THE GLEN AT WIDEFIELD FILING NO. 9

RESIDENTIAL SUBDIVISION CONSTRUCTION DRAWINGS

Kiowa Project No. 17038
September 25, 2018
Revised April 17, 2019

GLEN AT WIDEFIELD FILING NO. 9
GRADING AND EROSION CONTROL PLAN
GRADING AND EROSION CONTROL
EL PASO COUNTY, COLORADO

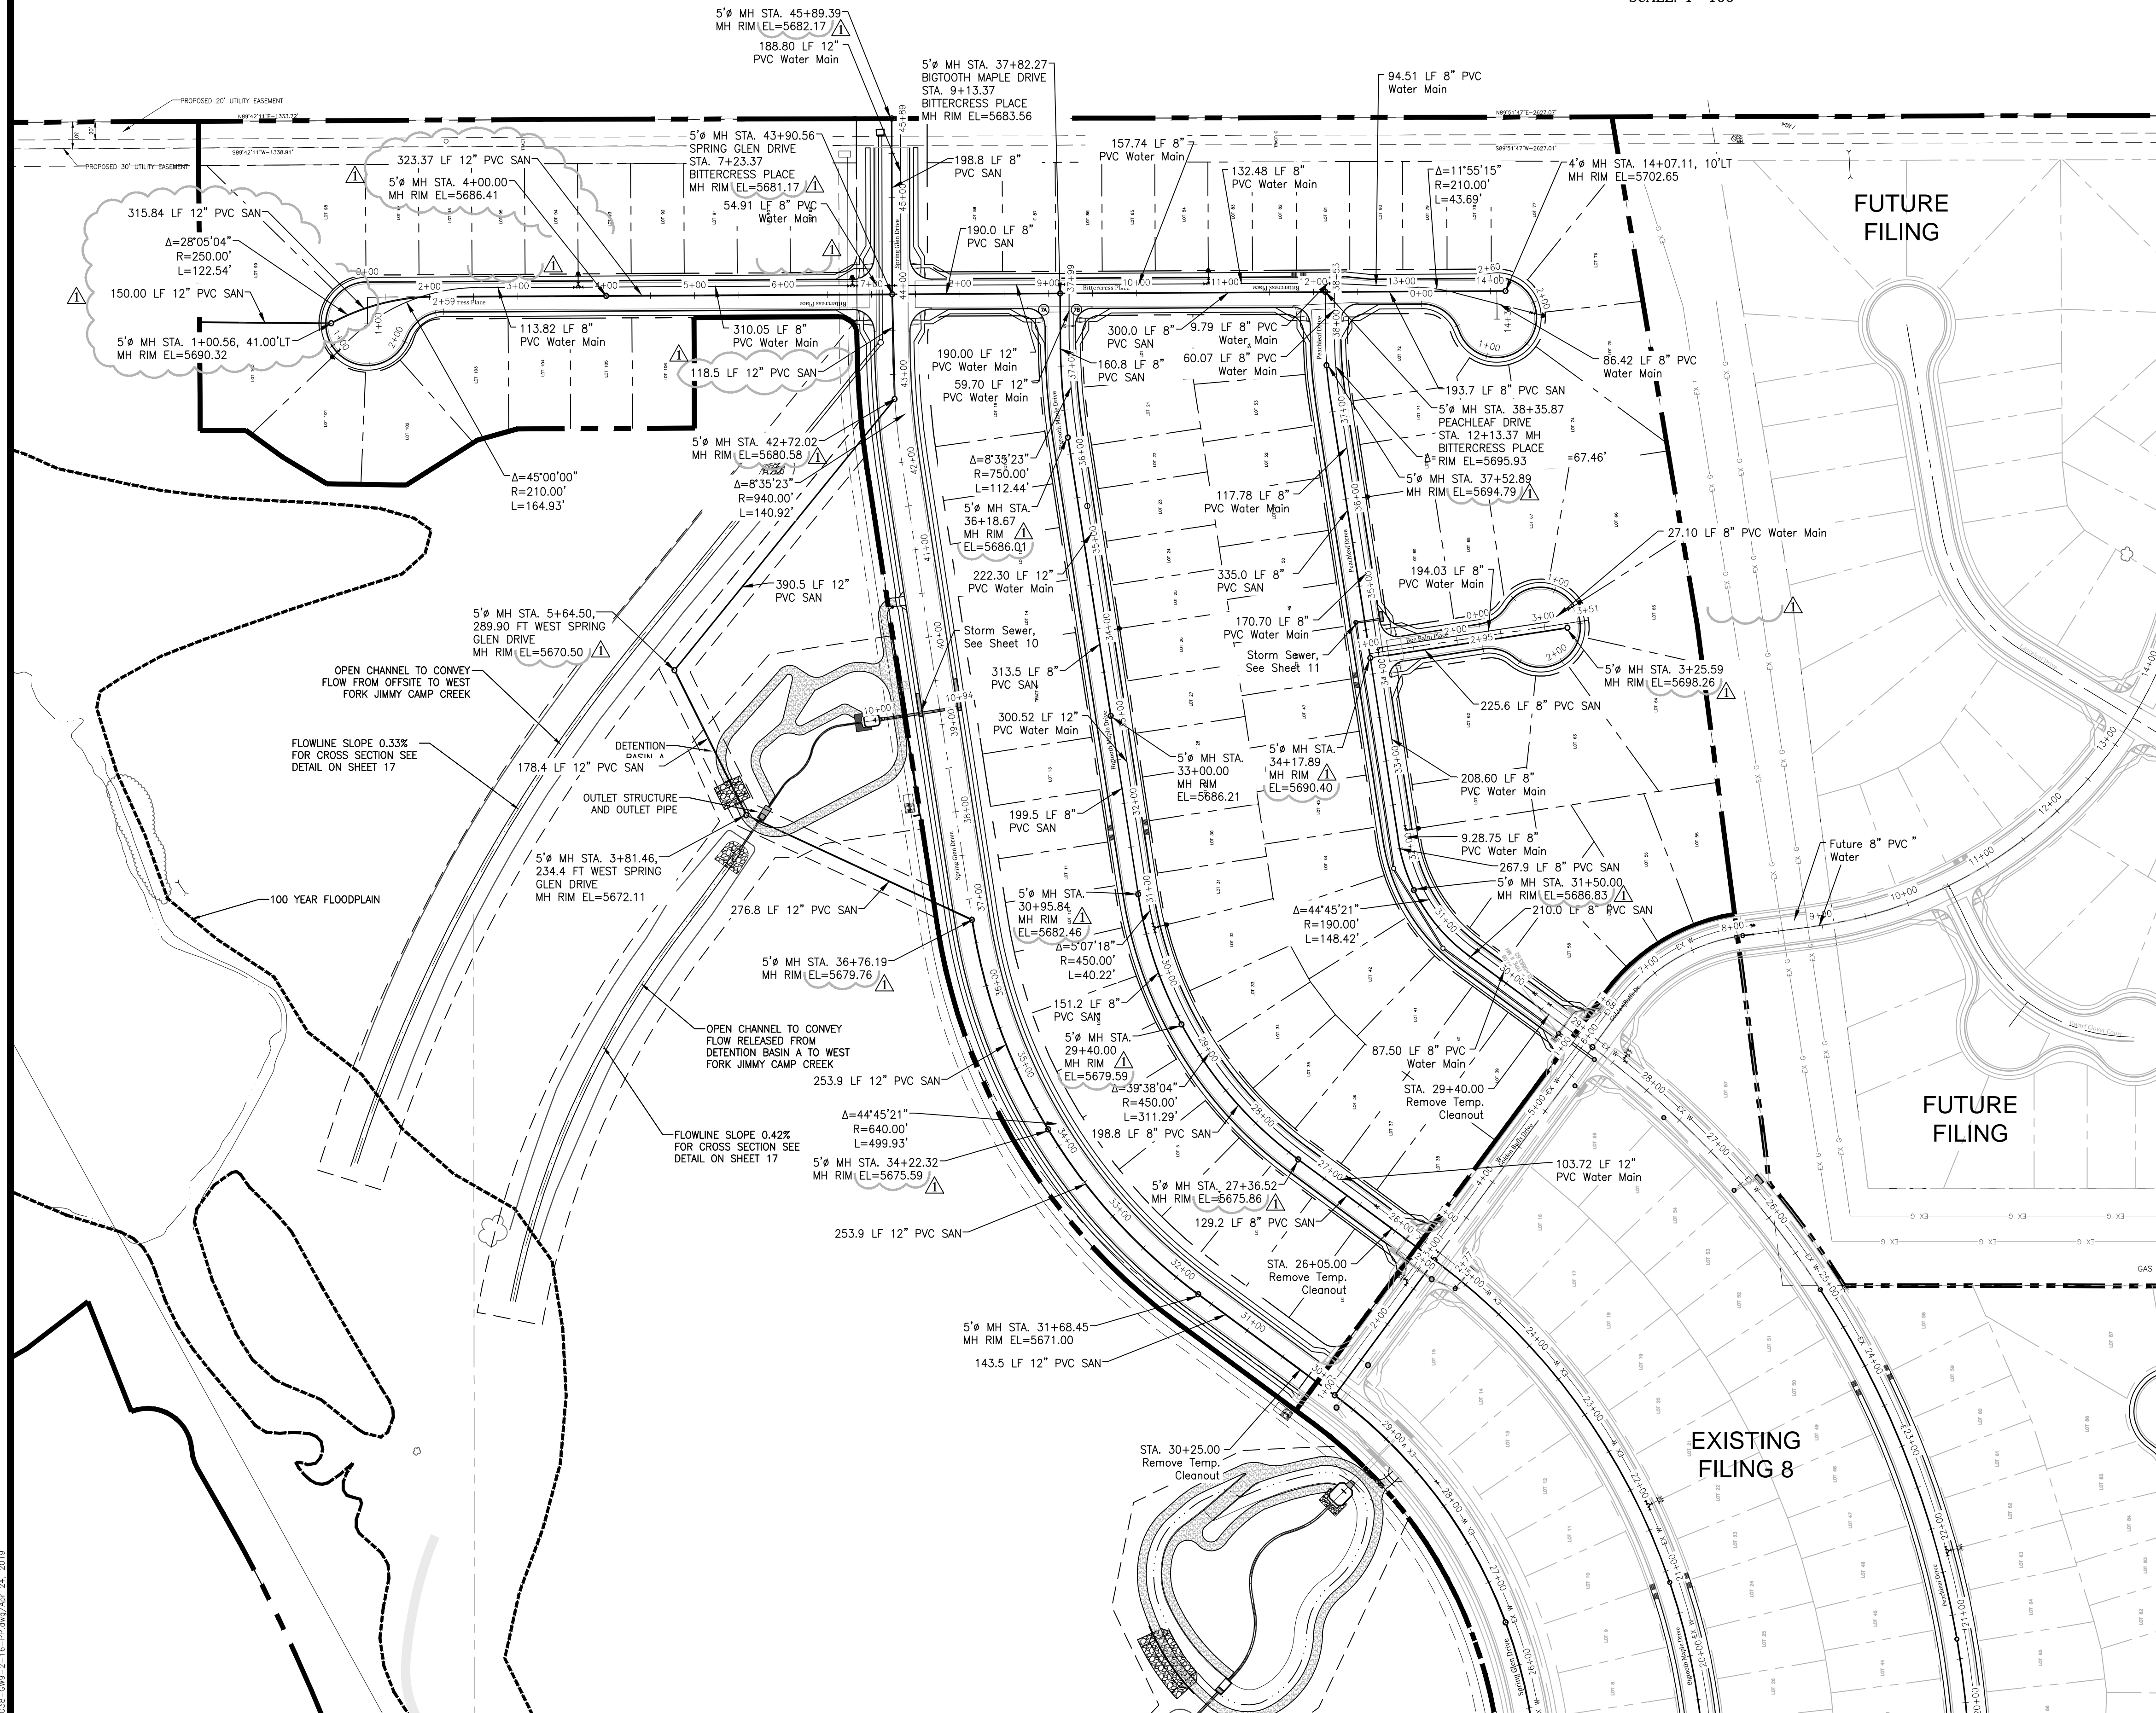
Revise grading between the ROW and sidewalk. This area needs to be flatter (2% slope). The steeper side slope shall occur west of the ROW. See grading south of the highlighted area.

O 19 EMERGENCY SPILLWAY
SCALE: NTS

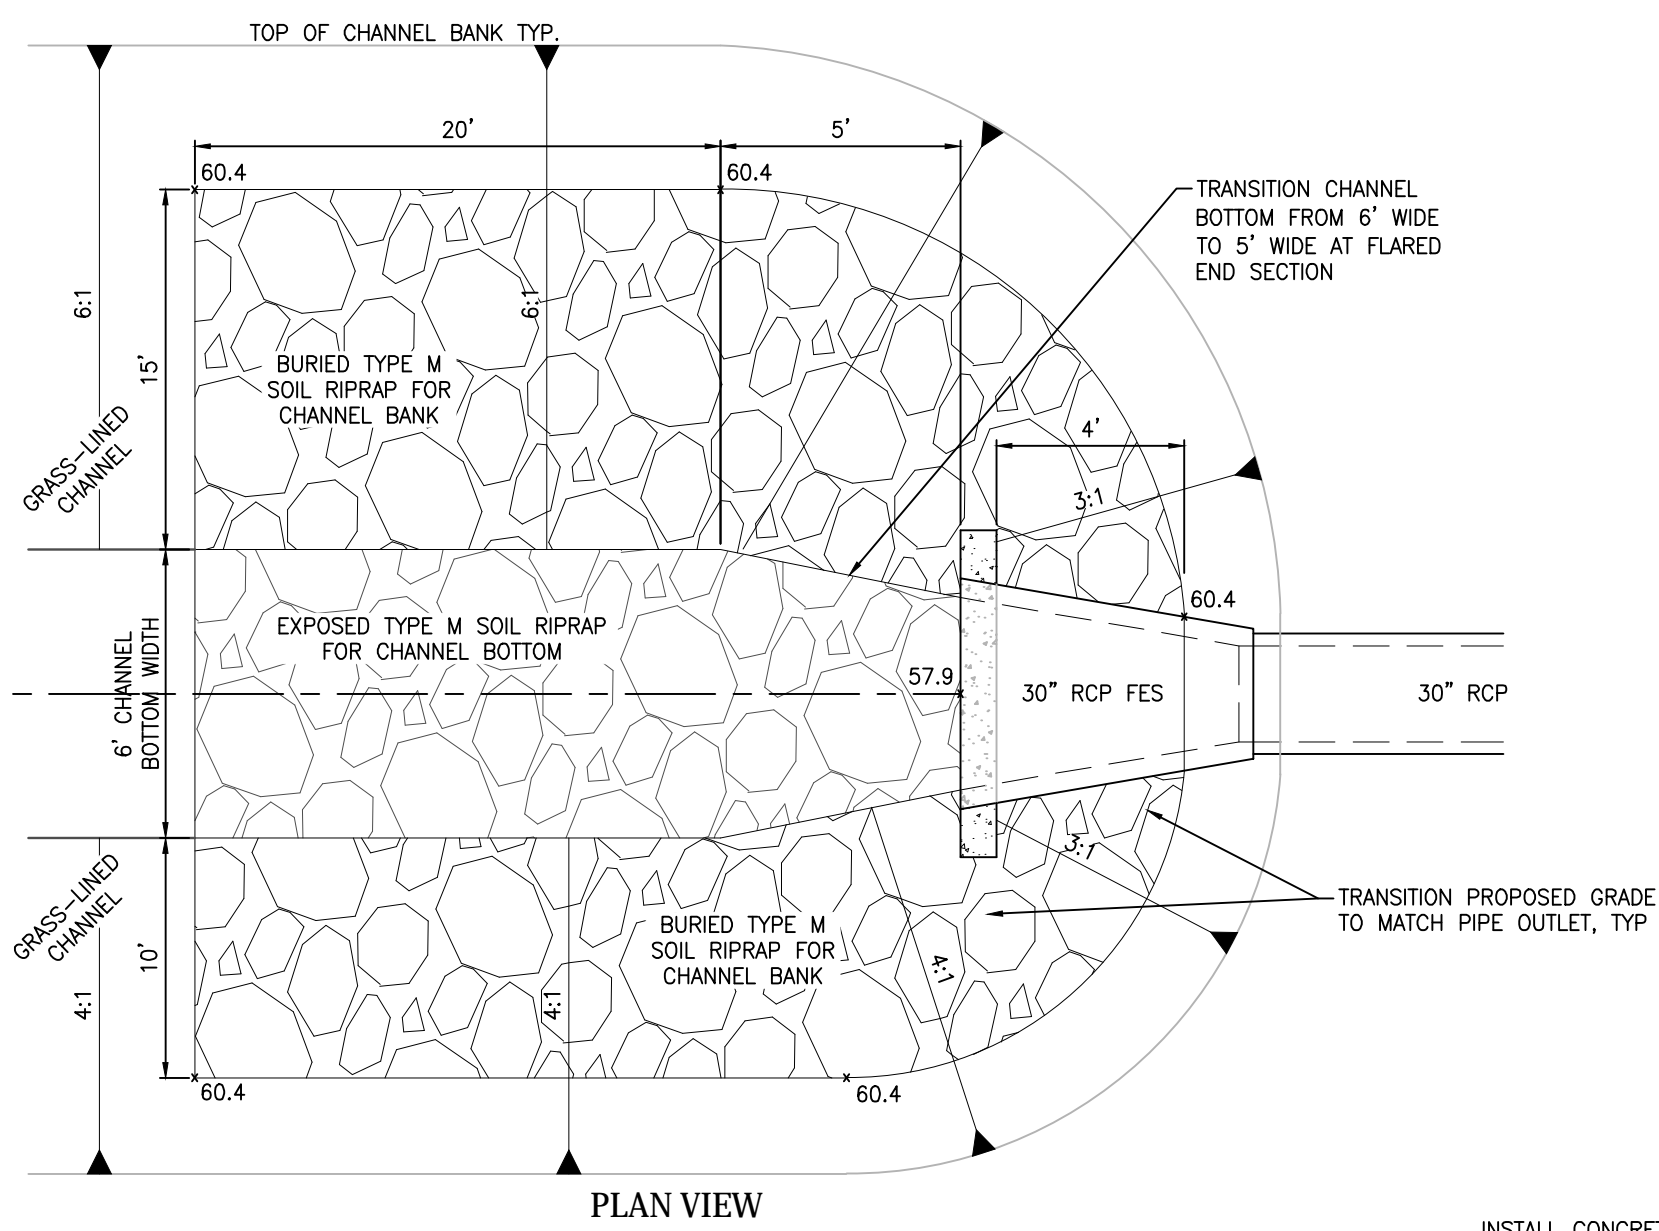
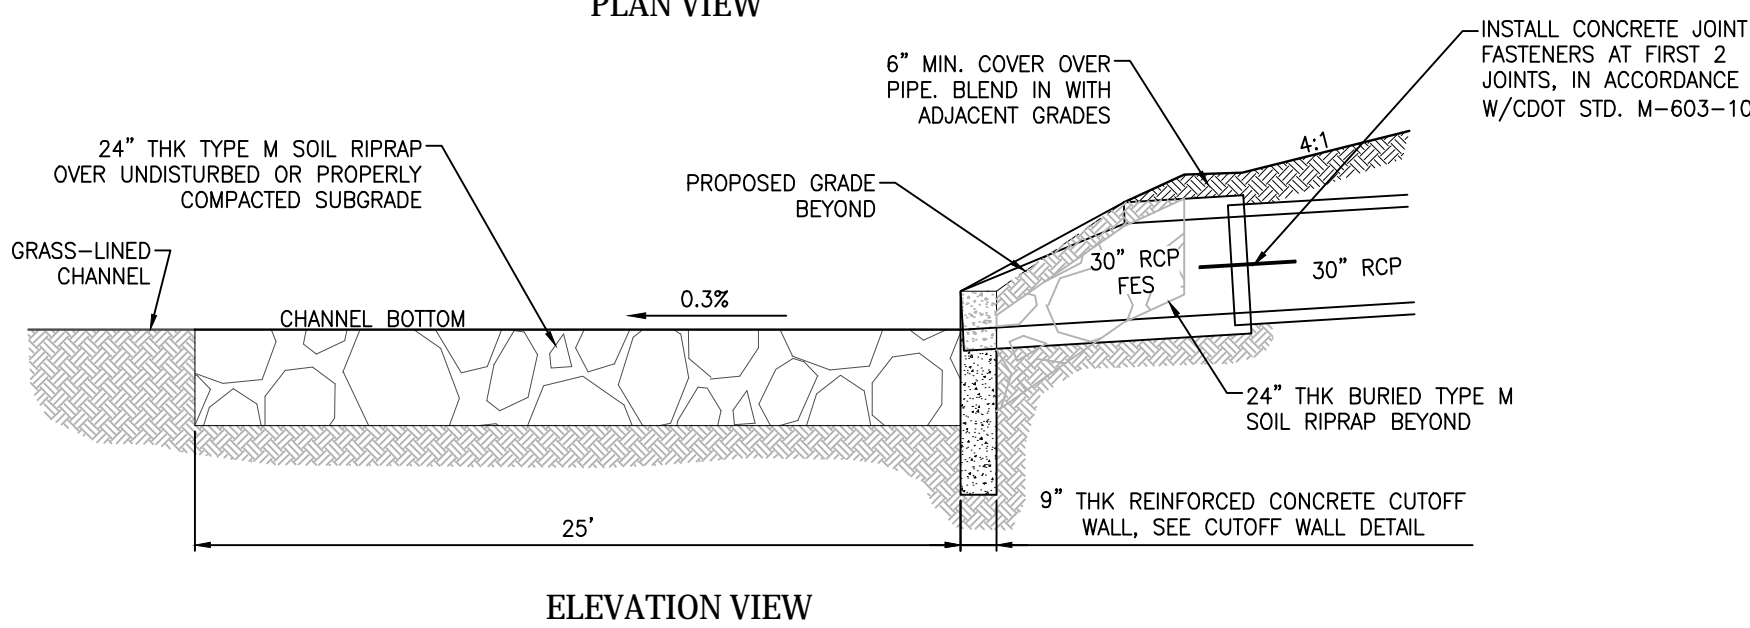
Adjust the emergency spillway elevations. The grading plan shows a top of embankment elevation = 72.0.
